Att: CDM Executive Board

Prot. PU 152/07  
Torino, 03/12/2007

**OBIJECT: Request for review for "Quezon City Controlled Disposal Facility Biogas Emission Reduction Project" (1258)**

Figure 1 – Payatas landfill plant (in red it is pointed out the area interested by the 2000 trashslide) – the location and the layout of the proposed LFG recovery and treatment plant are showed

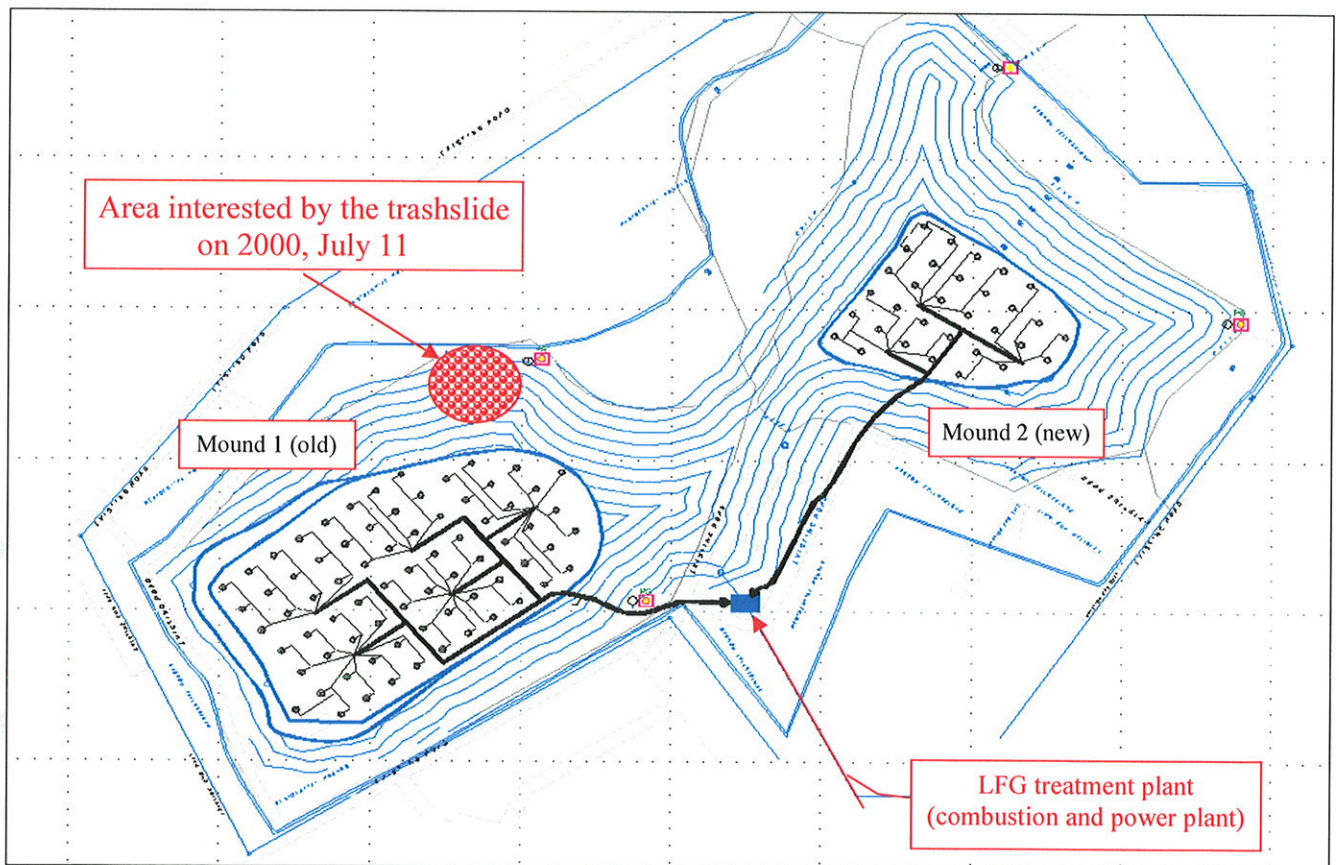
3. **in page 3 of the PDD, the PP states that “The 22-hectare disposal facility was the disposal site for Metro Manila’s municipal solid waste (MSW) from 1973 until July 2000 when it was prematurely closed due to a tragic trash slide” and that “...due to lack of alternative disposal sites, it was reopened in November 2000 pursuant to an Executive Order signed by President Joseph Estrada instructing the conversion of this open dump to a controlled dump and making it an exclusive dumpsite of Quezon City”. Further clarification is requested of which areas (cells) of the dumping site were affected by the slide, and to which degree they have become inoperative for methane**

**and leachate collection, which parts of the dumping site will be operated by the project with the specification of cells, location in relation to the slide site, etc.**

On July 10th 2000, after a period of heavy rain, a trash slide occurred in the Payatas "Open dump". Due to the trash slide no damage had been caused to methane and leachate collection system because of the fact that no methane and leachate collection system was implemented in Payatas landfill.

Figure 1 indicates the portion of the landfill affected by trash slide and the layout of the proposed biogas collection system and energy recovery plant.

The CDM project activity will interest only the wastes which were disposed after the reopening of the landfill as a “controlled dumpsite”, in particular from January 2001, as reported in Table 14 Annex 3 of the PDD, until the cut off date of the landfill at the end of 2007. Please note that for the 2007 it has been foreseen a disposal value equal to 2006. In other words, for the forecasted LFG calculation production, we only considered the waste filled in the two mounds after January 2001 (see B in the cross section showed in figure 2). Since January 2001 the landfill has been filled up with new wastes, which have been disposed on both the existing mounds, as represented in Figure 2:
